Conceptual Review Agenda

Monday, August 19, 2013

Re: Trilby Rd & Avondale Rd - Single Family/Duplex

Re: 2025 W Harmony Rd - Single Family/Duplex

CONCEPT SKETCH STUDY 2.21.13

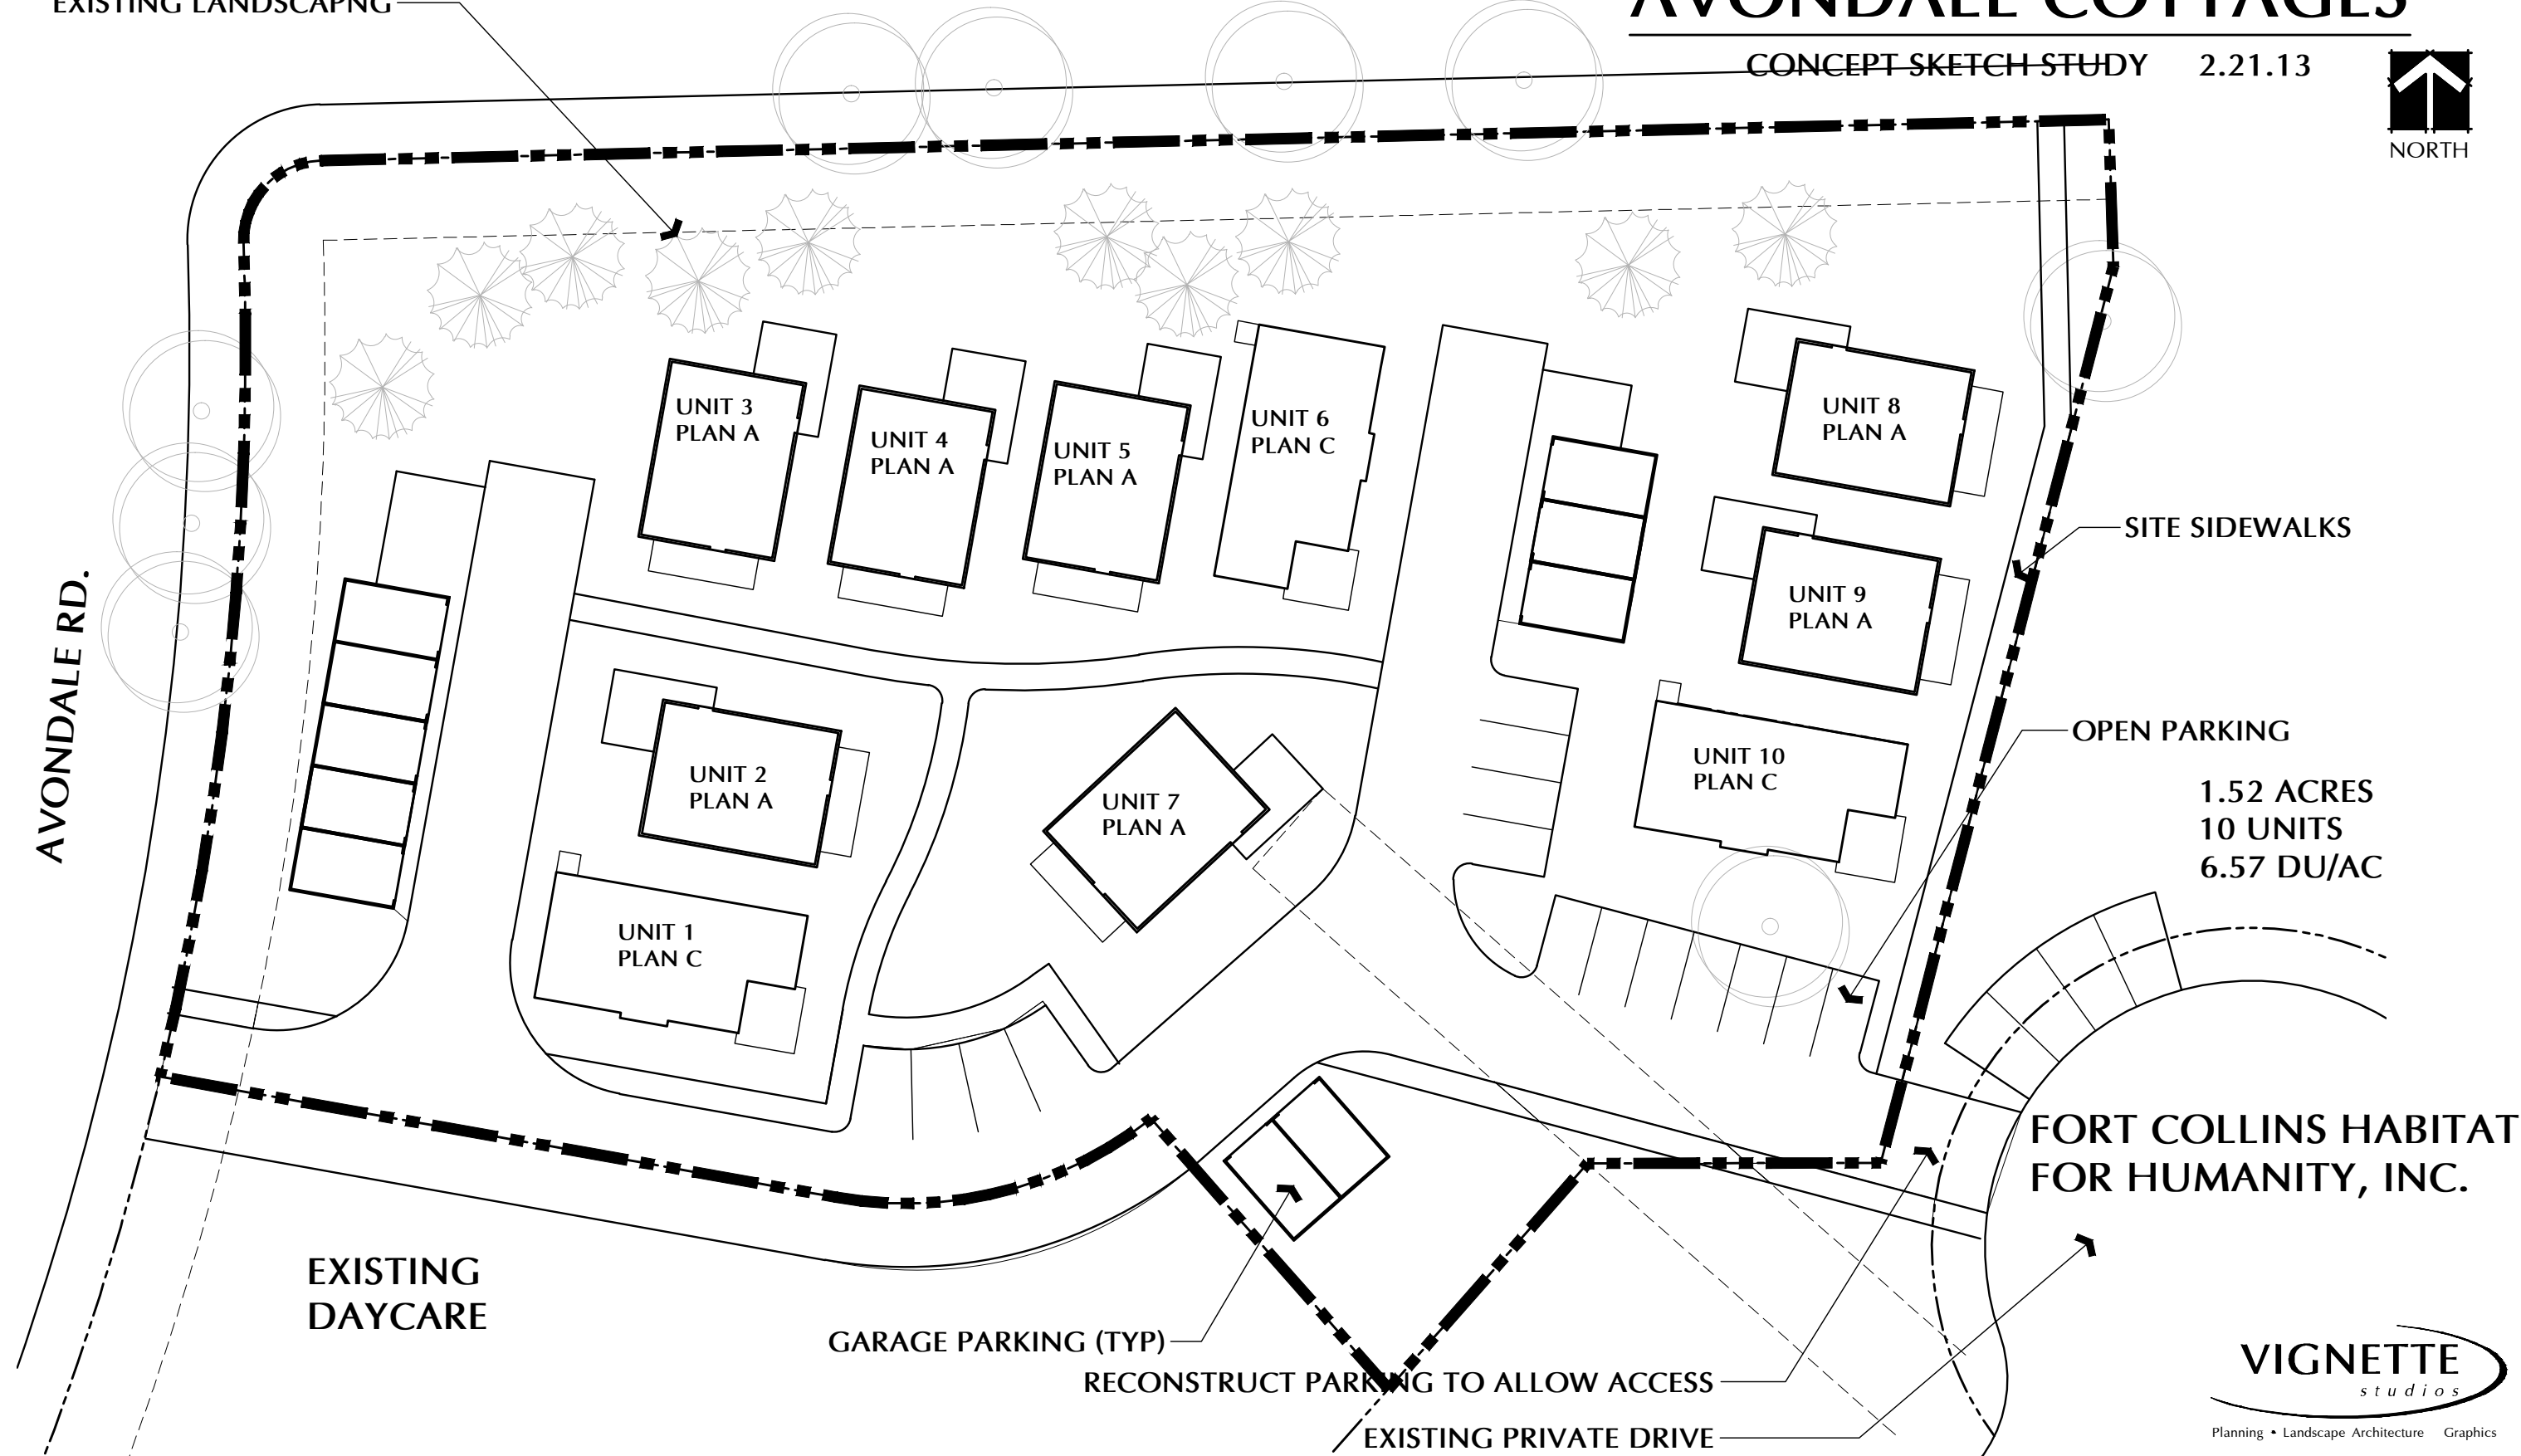
As no scale was provided on the site plan, it is unclear if this code requirement is being met.

As no scale was provided on the site plan, it is unclear if this code requirement is being met.

If the proposed connection to the cul-de-sac cannot be achieved, further discussion is required to determine a secondary access to the site.

8. Taking access off the cul de sac will result in the loss of parking spaces and this could affect the existing site plan. Please confirm with zoning department on any requirements.

9. It appears that truncated domes are not located on either the Trilby or Avondale intersection corners and need to be included as a part of this project.

2. The relationship of homes to streets is an important aspect of development. A Connecting Walkway is required to the front facades of the homes, without crossing vehicle use areas or going around buildings or parking lots. The plan as shown does not meet the standard given the orientation of units primarily to an internal parking drive. A Modification of Standard would be required to support a different plan that is as good or better than a plan that meets the standard.

HARMONY COTTAGES CONCEPT PLAN 'A'

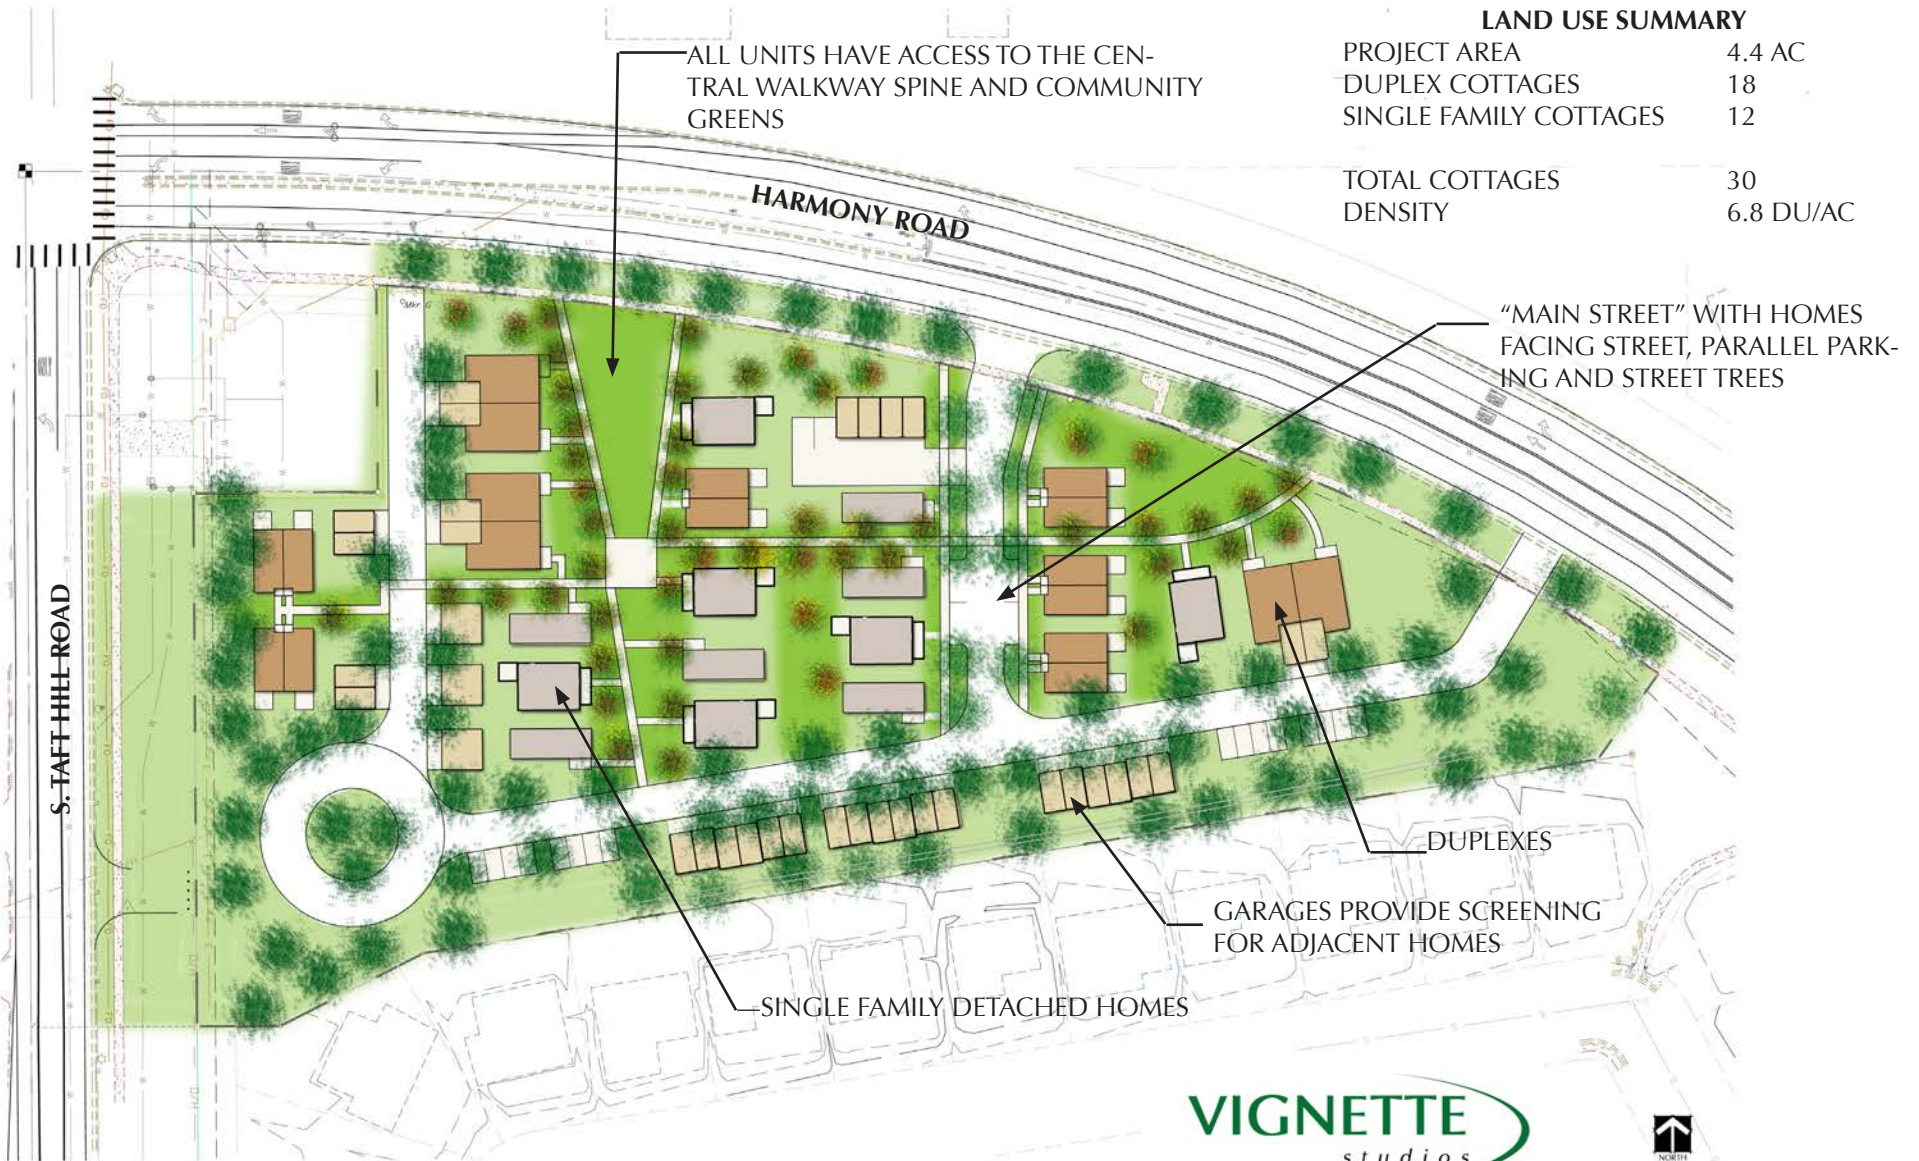
4. Can the 4-car garage attached to the small parking lot closest to Harmony be moved to the south and the house behind it moved in its place?
5. Any consideration to solid fencing the south and east sides of the Ft. Collins - Loveland Water District property at the s-e corner of W Harmony Rd and S Taft Hill Road?

6. The site layout appears to be a little close to the south property line to accommodate a drainage swale along the property line. Any drainage swales must be in separate tracts and cannot be on private properties. There is the option to route the runoff from the existing lots through the site and not have a swale along the property line.

The required turning radii of a fire apparatus access road shall be a minimum of 25 feet inside and 50 feet outside. These turning radii shall apply to all portions of the fire lane including the proposed roundabout on the SW portion of the site.

This code requirement is not being met on the current conceptual site plan. At the 8-19-13 cr meeting, the applicant proposed the addition of another connection to Harmony Rd. at the west end of the project. This connection, while resolving fire department concerns, may present other obstacles for transportation coordination. Further discussion is recommended.

9. The two apparent accesses onto Harmony Road appear to be consistent with the previous Innovation Island submittal, however their access spacing and location will need to be formally reviewed with the new submittal and not necessarily guaranteed. Variances to LCUASS may be needed for approval. (Note that access and intersection spacing requirements are not as strict with the internal roadway being private drives instead of public streets.)
